CALIFORNIA COASTAL COMMISSION

SUBJECT: Revised Findings for UCSB Long Range Development Plan (LRDP) Amendment 1-04 and Notice of Impending Development (NOID) 2-04, for the San Clemente Housing Project, for Public Hearing and Commission Action at the September 2005, Commission Meeting in Eureka.

COMMISSION DECISION: STB-MAJ-1-04 Certified with Suggested Modifications; NOID 2-04 Approved with Conditions

EXHIBIT 18
LRDPA 1-04 & NOID 2-04
Revised Pedestrian Trail

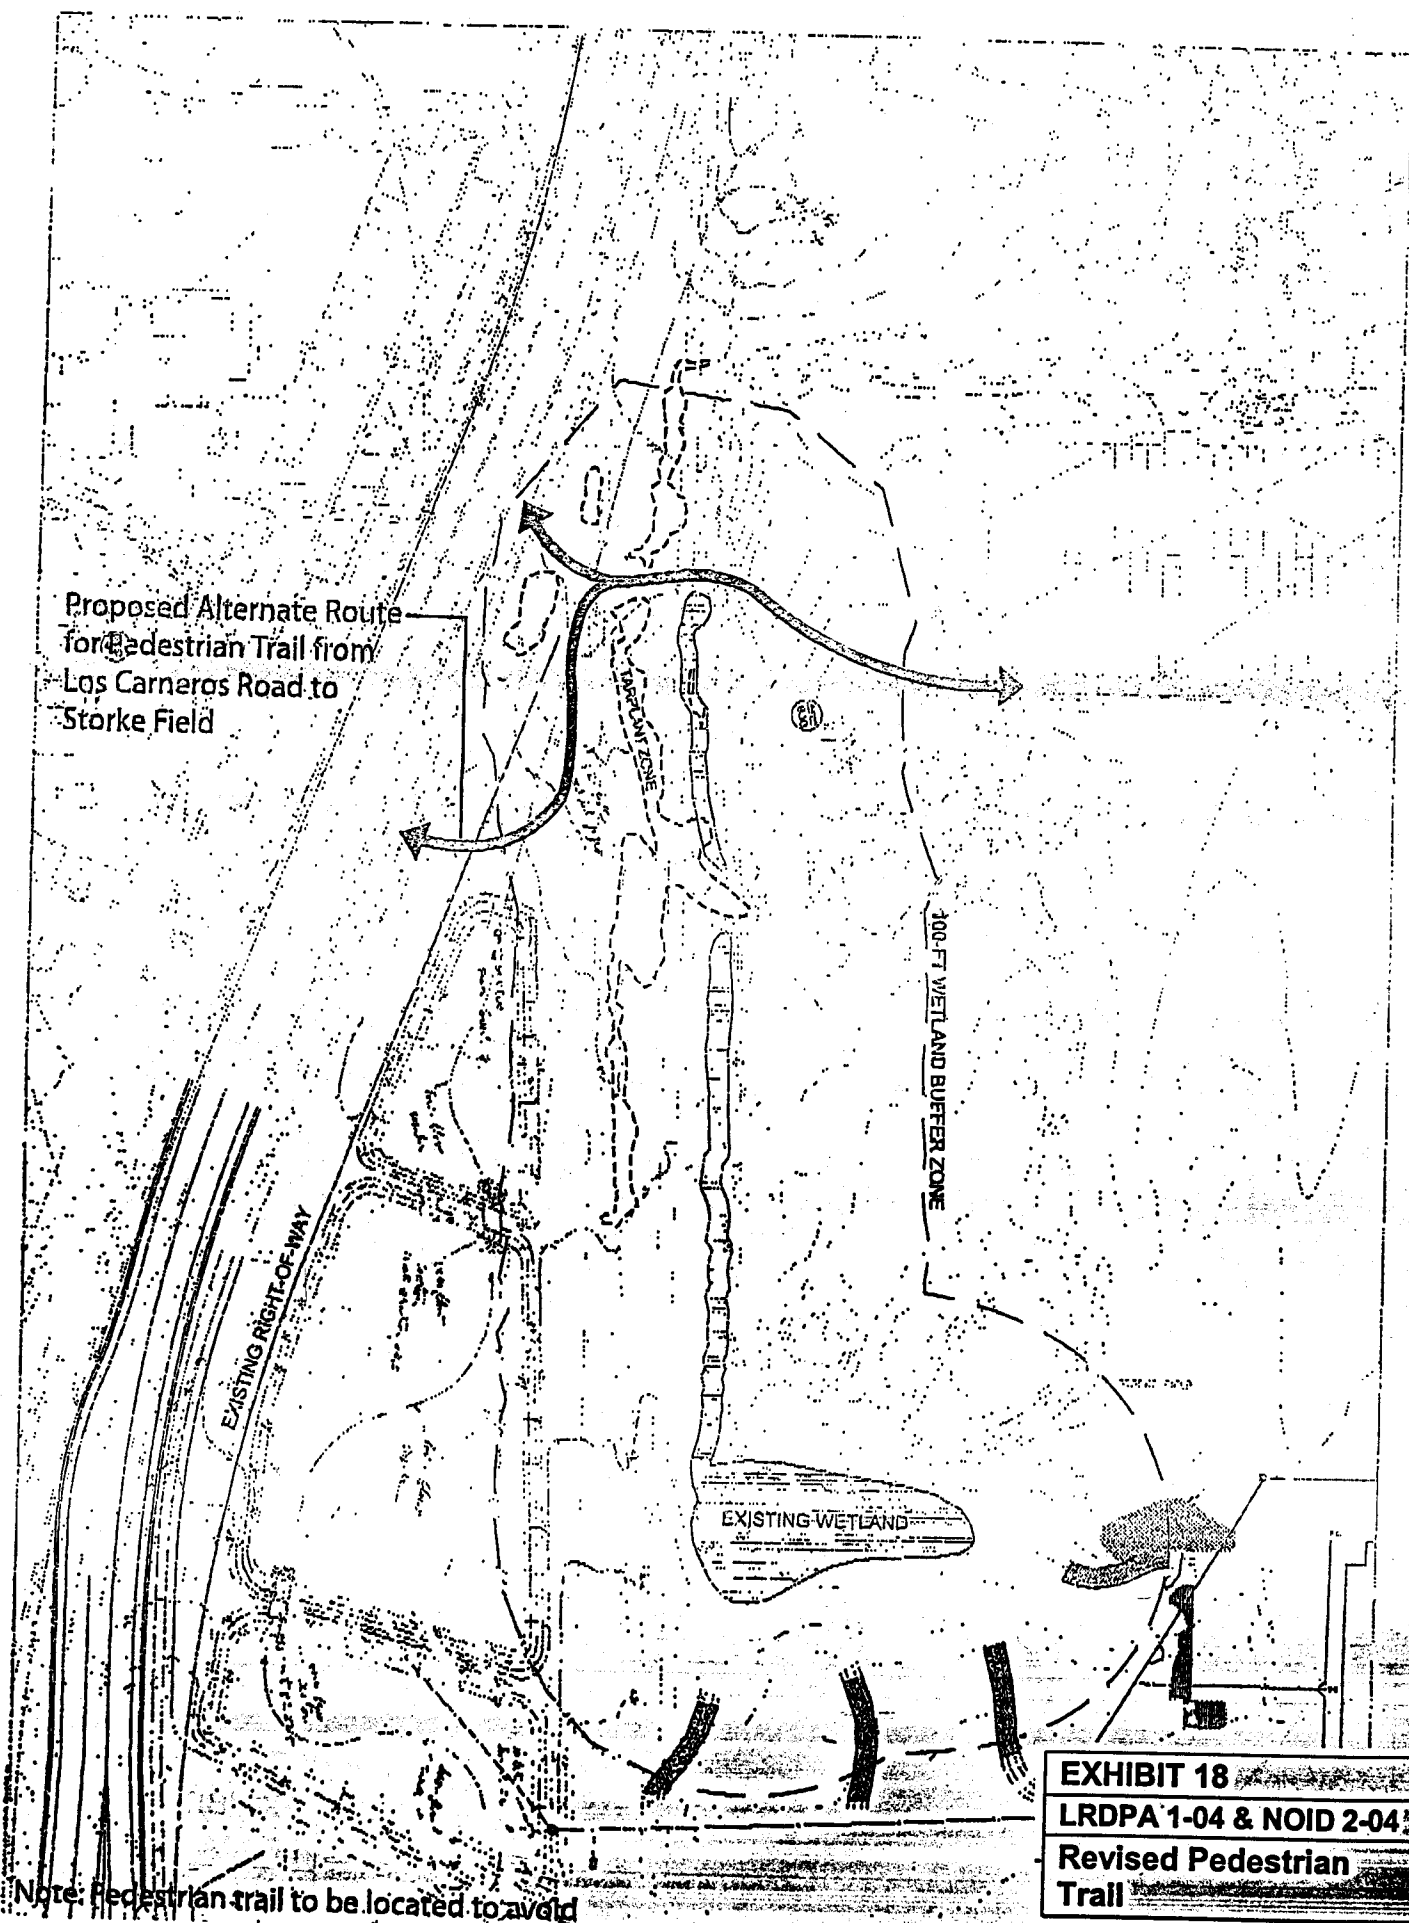
with Section 30240 of the Coastal Act, included within the certified LRDP. Therefore, the Commission requires University to reroute the proposed pedestrian path to avoid the tarplant, as shown in Exhibit 18, pursuant to **Special Condition Two (2)**. No southern tarplant would be removed as a result of the revised route. The revised route would still be located within tarplant buffer area; however, the amount of use is not anticipated to be extensive since the revised route is limited in length through the habitat area; it is not connected to other pathways that are attractive for hiking or jogging; and its intended use is for education and research purposes. The route connects the west end of Parking Lot #38 to Los Carneros Road, but does not provide a main thoroughfare for any particular group of users to a given destination. Therefore, the trail is anticipated to receive limited traffic and low-impact uses. However, to ensure that there are no adverse impacts as a result of such use, Special Condition 2 further requires limits the construction of the trail to a compacted soil, or Class 2 road material, path and further requires a low-profile post and cable fence with environmental signage to prevent trespass. These requirements ensure that wetland and ESHA resources are protected consistent with Coastal Act Section 30240 and LRDP Policy 30240(a).8 which states that users shall be encouraged to remain on existing trails, and signs shall be posted.

- (3) *Pedestrian Footpath*. As required pursuant to Special Condition Two, the pedestrian footpath shall be relocated outside of the wetland and tarplant areas.
